Access Compliance Report

Public Rights-of-Way

(Island Curb Cuts)

| Intersection ID: 10031842 | Main Street: MINTWORTH_AV | Cross Street: N/A | Location: E |

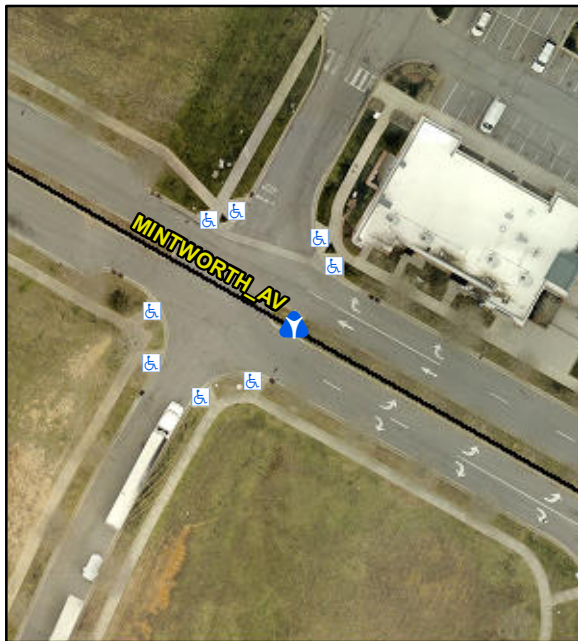
| ADA ID: AC17C560A623 | Curb Cut Type: MedianRefuge2 | Initial Pass/Fail: Fail | Overall Compliance: No |

| Compliance | Description | Data | Compliance | Description | Data |
|------------|----------------------|-------|------------|-----------------------------|------|
| No | Refuge 1 Width (In) | 47.5 | N/A | Gutter 1 Lip Ht (In) | N/A |
| No | Refuge 1 X Slope (%) | 6.0 | N/A | Gutter 1 X Slope (%) | N/A |
| No | Refuge 2 Width (In) | 47.5 | N/A | Gutter 2 Lip Ht (In) | N/A |
| No | Refuge 2 X Slope (%) | 5.3 | N/A | Gutter 2 X Slope (%) | N/A |

Remove & Replace Entire Refuge.
